# **KHNP Quality Assurance Program Description (QAPD) for the APR1400 Design Certification**

**APR1400-K-Q-TR-11005-NP-A, Revision 2**

SUBJECT: ACCEPTANCE OF ADVANCED POWER REACTOR 1400 TOPICAL REPORT  
APR1400-K-Q-TR-11005-NP, REVISION 5, "KHNP QUALITY ASSURANCE  
PROGRAM DESCRIPTION FOR THE APR1400 DESIGN CERTIFICATION"

# **SAFETY EVALUATION FOR TOPICAL REPORT APR1400-K-Q-TR-11005-NP, REVISIONS 4, “KHNP QUALITY ASSURANCE PROGRAM DESCRIPTION (QAPD) FOR THE APR1400 DESIGN CERTIFICATION” (RQ4804)**

Figure II. 1-1 KHNP APR1400 DC Project Organization

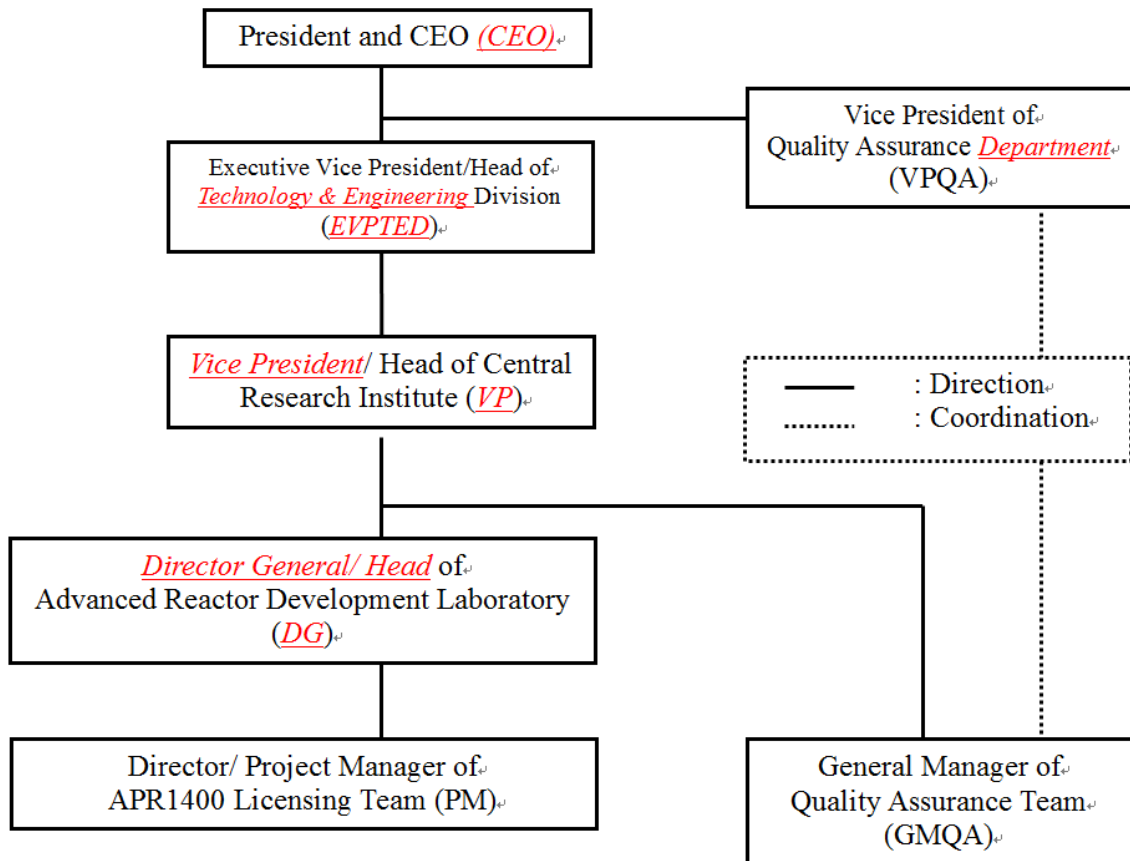
The Director General (DG) of KHNP Central Research Institute (CRI) to direct the Deputy Director General of Advanced Reactor Development Laboratory (DDG) in addition to the current duties and requires the Director of APR1400 Licensing Team reports to KHNP's DG and the DDG.

The Executive Vice President's title changed from "Safety & Technology Division (EVPSTD)" to "Planning & Community Cooperation Division (EVPPCC)."

The above changes were included in TR APR1400-K-Q-TR-11005-NP, Revision 4. The NRC staff determined that these minor organization changes are not reductions in commitment from TR APR1400-K-Q-TR-11005-NP, Revision 2 (ADAMS Accession No. ML13238A025), previously accepted by the NRC; and therefore are acceptable.
